## Comment Response Sheet

PUBLIC WORKS  
PLAN REVIEW NOTICE  
Phone 305-673-7080 Fax 305-673-7028

ANGLED JAMB DETAIL  
SCALE: 3/4"=1'-0"

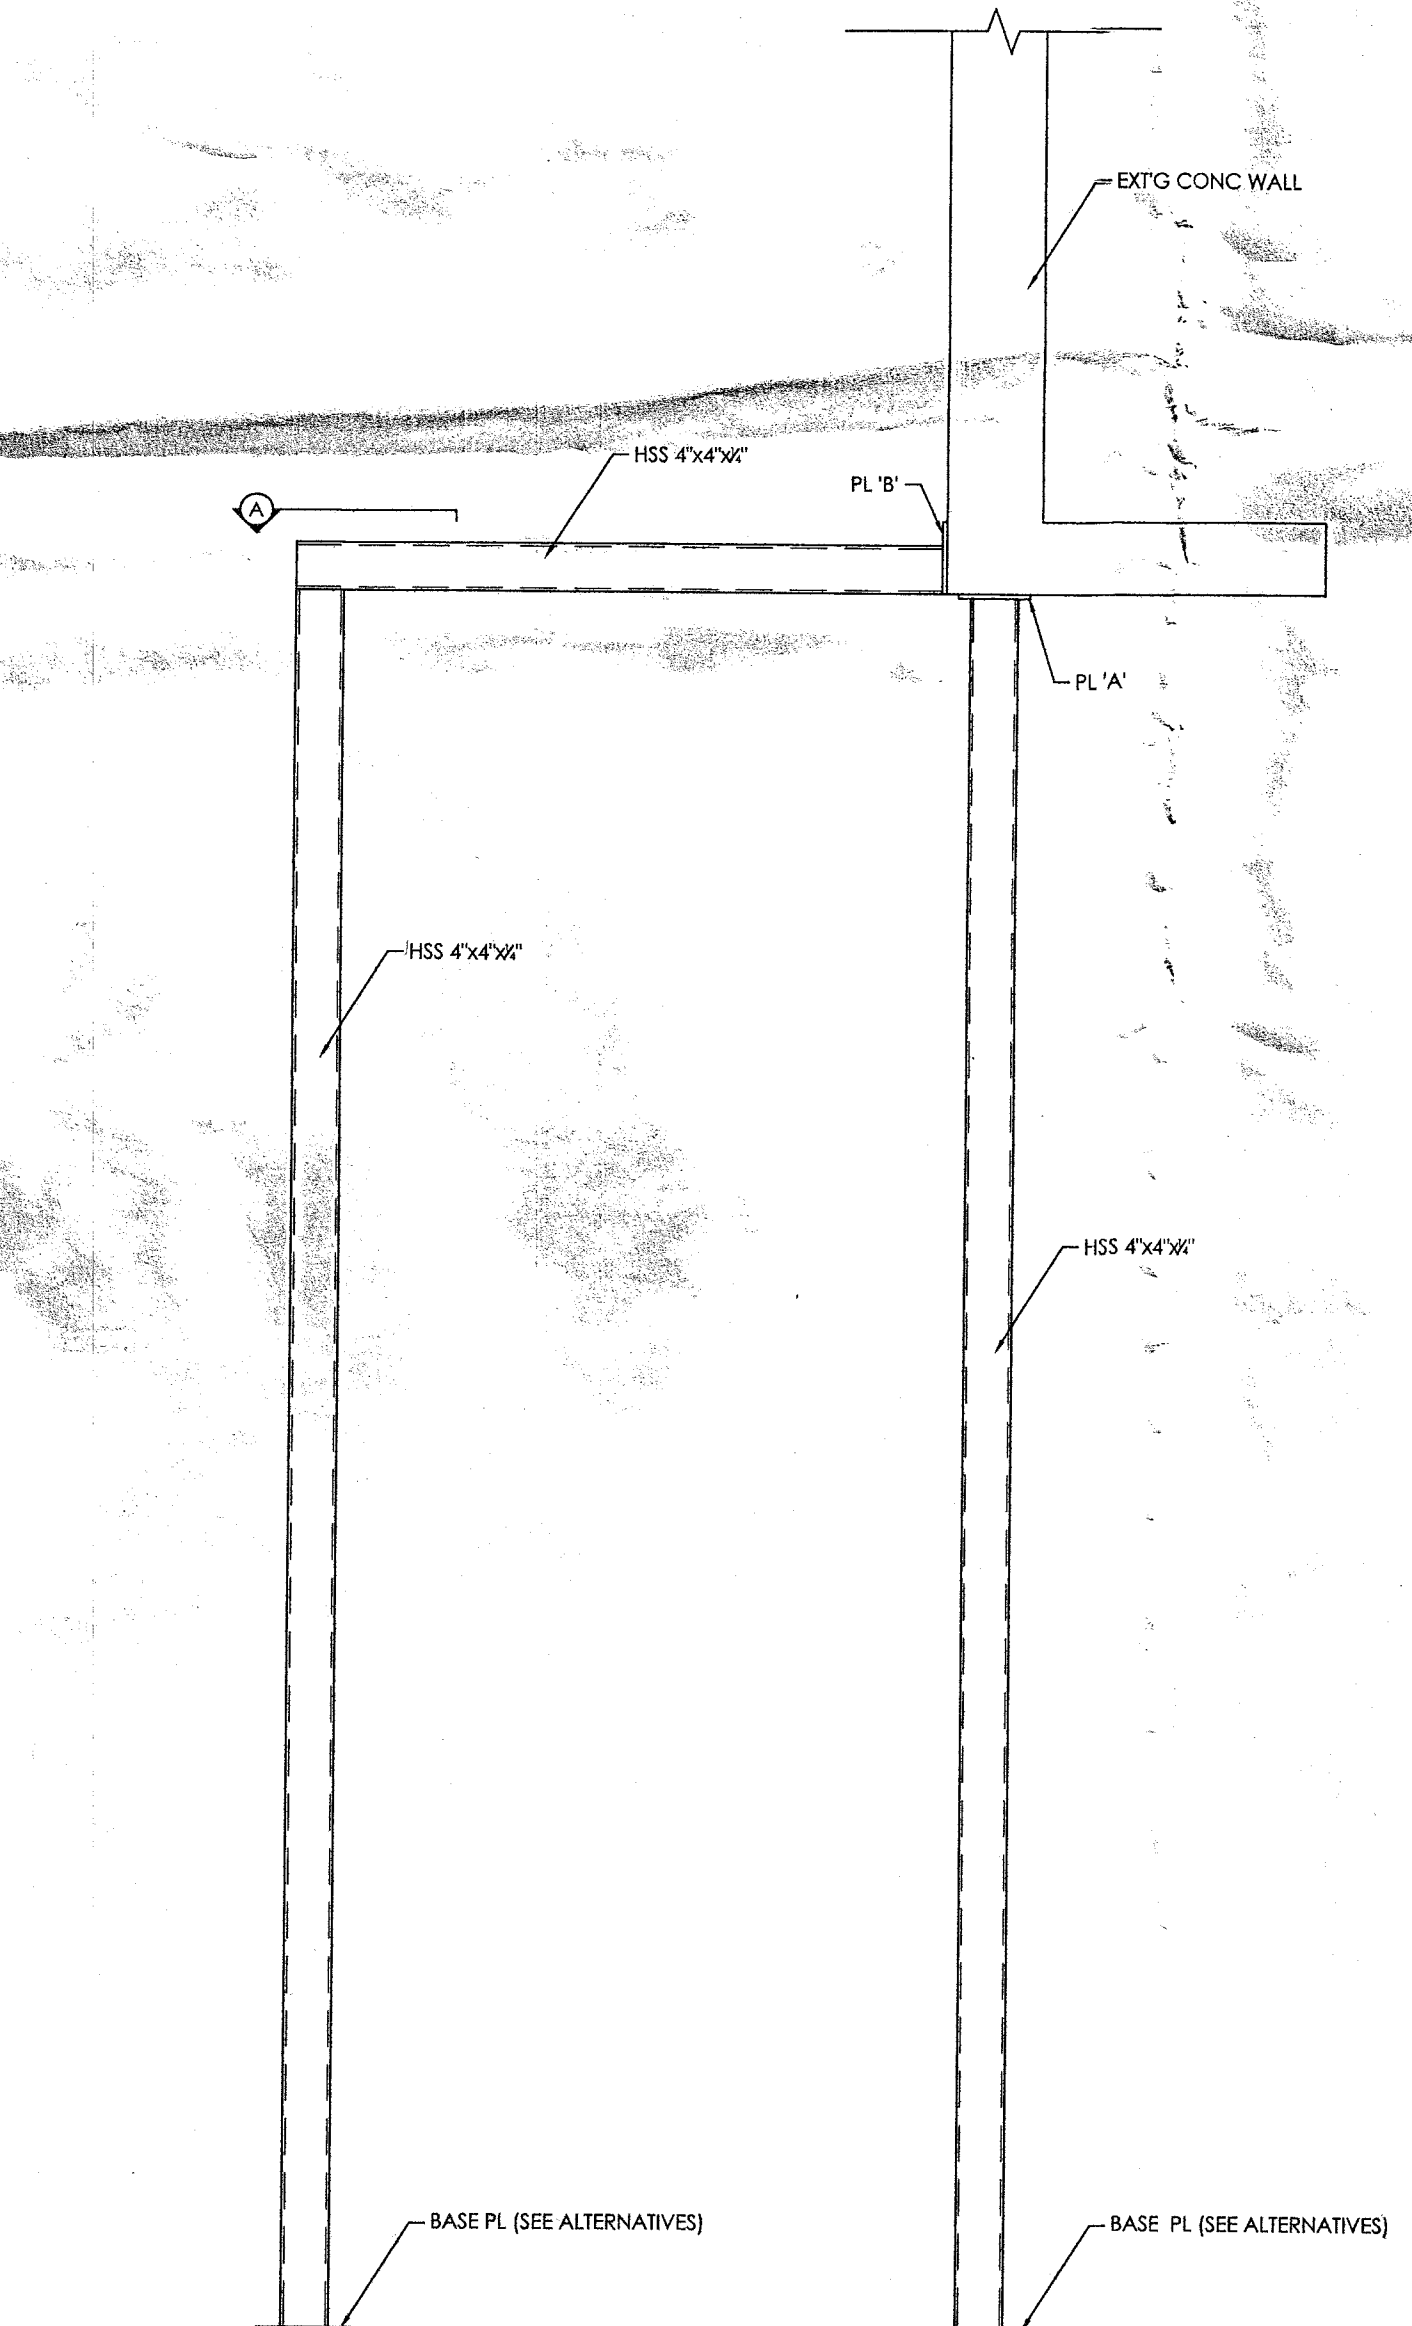
- Provide demolition plans. Clearly show existing structural elements to be removed and to remain.
  - A demolition plan can be provided if required, but it will merely denote that the existing storefront is to be removed. We are replacing the existing storefront which does not have any structural components. We are placing a structural framework of steel tubes though none is currently existing.

- Provide structural plans and sections and clearly identify existing structure to remain that will support the proposed storefront.
  - The existing structure will not be modified. There is a large concrete wall/beam above the storefront that spans the opening of the storefront. The framework we are providing is independent of the existing structure.

- Structural steel framing:
  - a) Provide plan view details for architectural piers of different shapes with vertical tube inside. Provide design information for framing of those piers. Provide detail for joint between those piers and the storefront jamb.

- b) Provide calculations for members and their connections. Include horizontal member with eccentric bolts meeting the wall at 90 or 135 degree angles.

- There are no architectural piers. The storefront will consist of the glazing and steel framework. Plans have been updated to more accurately reflect this. Please see added "Section A" & "Angled Jamb Detail" on Sheet 2.
